SUBMISSIONS REPORT LEP AMENDMENTS

69C, 81 & 85 TRINITY POINT DRIVE
MORISSET PARK

RZ/14/2021
PROPOSED MIXED USE DEVELOPMENT
(TOURISM, HOSPITALITY & RESIDENTIAL)

JOHNSON PROPERTY GROUP PTY LTD
MARCH 2023

Figure 1: Proposed Hotel Ground Levels

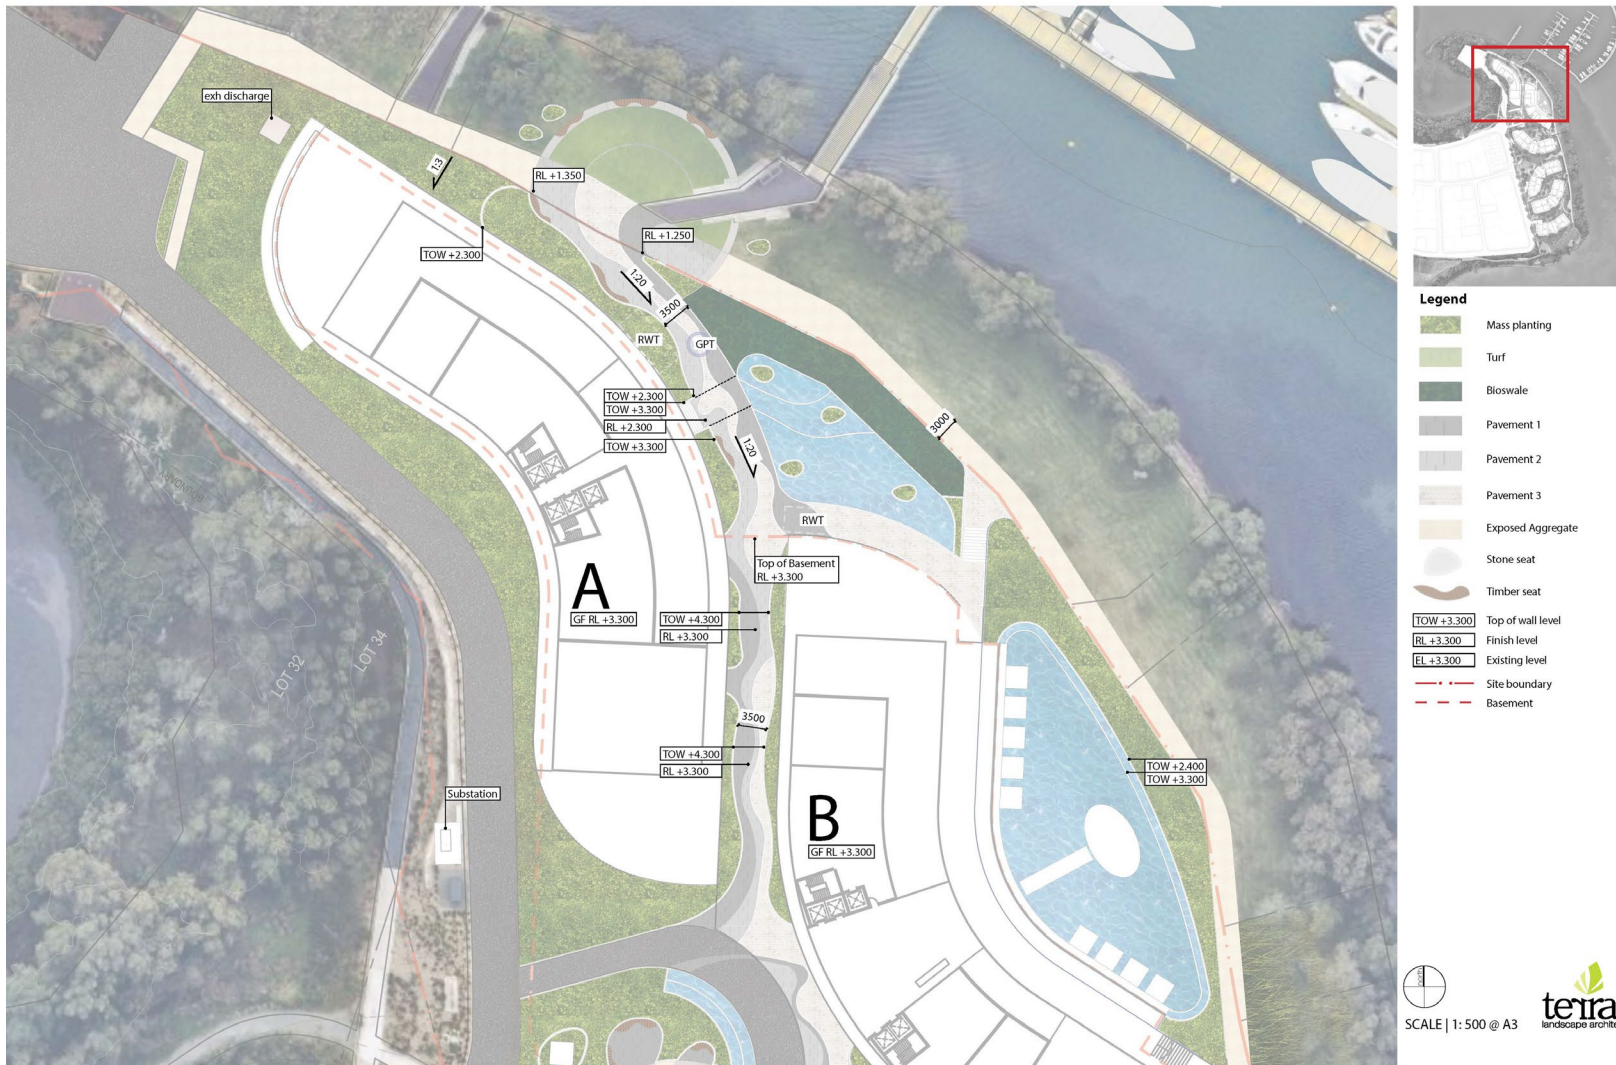
It should also be noted that although Buildings A and B would be built on land which currently would have a hydraulic hazard of up to H4 in the 1% AEP lake flood in 2100, most of the ground level immediately surrounding these buildings will be raised to 3.30 m AHD or higher, placing it above the level of a PMF in 2100 (Figure 1). Land between the buildings and Trinity Point Drive via the porte cochere would not drop below 3.30 m AHD (Figure 2). Therefore, vehicular and pedestrian access to the hotel would be flood free in all floods up to and including the PMF in 2100.

In addition, both Buildings A and B can be accessed via the basement, which is protected up to the 2100 PMF level via passive measures, such as ground and floor levels and ramp crests. Access to the basement from Trinity Point Drive is flood free in all events up to and including the PMF in 2100, with the road and all ramp crests at or above 3.3 m AHD. Therefore, the proposed development does not directly increase the risk to life, health or property of people accessing the hotel buildings, including emergency services personnel.

The proposed hotel development does potentially place a large number of people in a location adjacent to land that could be subject to flooding. However, they would have no need to enter the flood waters in events up to the 2100 PMF as they can enter and exit the building on flood free land.

Figure 8: Flood hazard vulnerability curves (Smith et al., 2014)

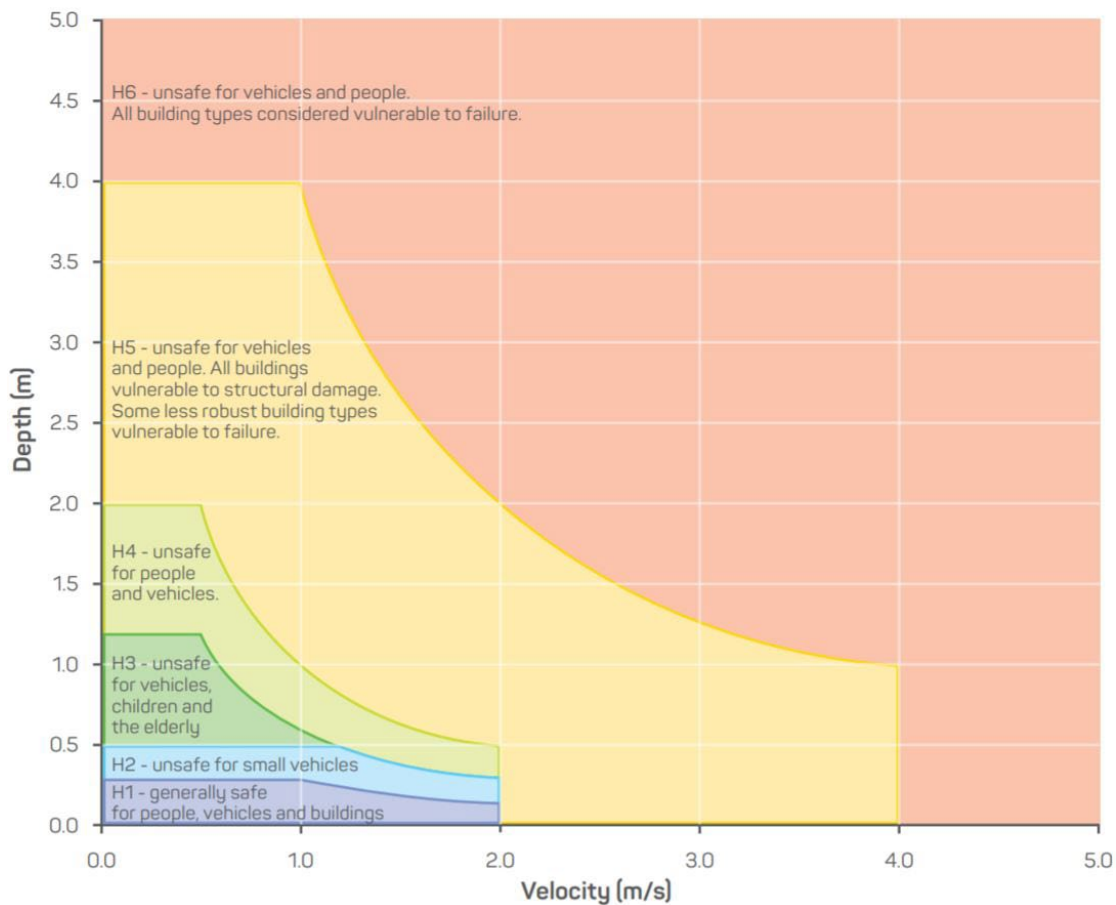
Provide further information regarding the Probable Maximum Flood (PMF), including the flood hazard categorisation during the PMF event and a statement regarding whether the site is located within a PMF floodway.

According to the current method of hydraulic hazard classification (Figure 8), this would place the lowest parts of the site in an H5 category. The hydraulic classification would be in lower categories in those areas which have higher ground levels. With reference to the ground levels in Figure 1, Figure 2, Figure 4 and Figure 5, ground levels immediately east of the buildings will generally be around 2.3m AHD or higher, placing them in a H3 category or lower in the 2100 PMF.

Of course the areas between the buildings and to their west are above the 2100 PMF level and have no hydraulic hazard.

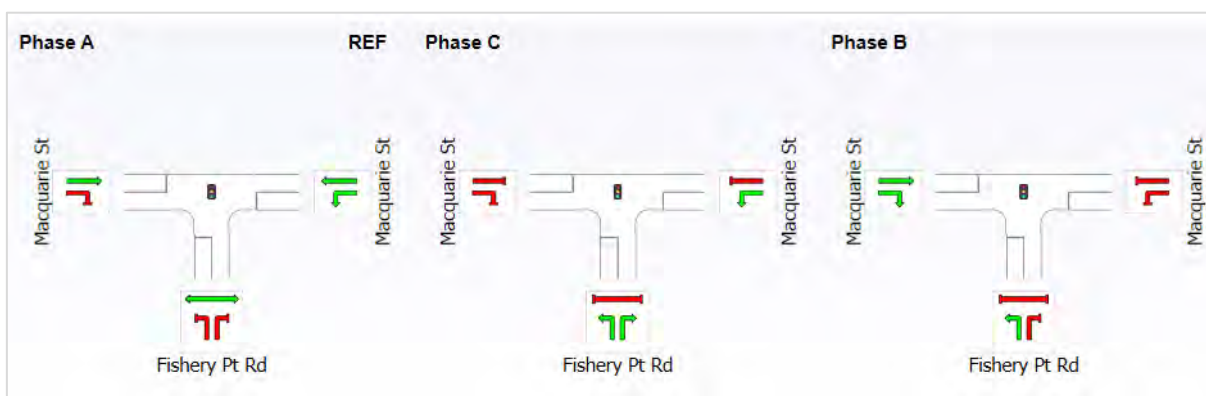
e) It is advised that the traffic signals in Macquarie Street/ Fishery Point Road are currently operating with a different phase order (A-C-B) to that modelled (A-B-C).

The Macquarie Street- Fishery Point Road intersection phasing arrangement has been updated to 'A-C-B' as shown below.

This update has been adopted across all scenarios within the SIDRA model.
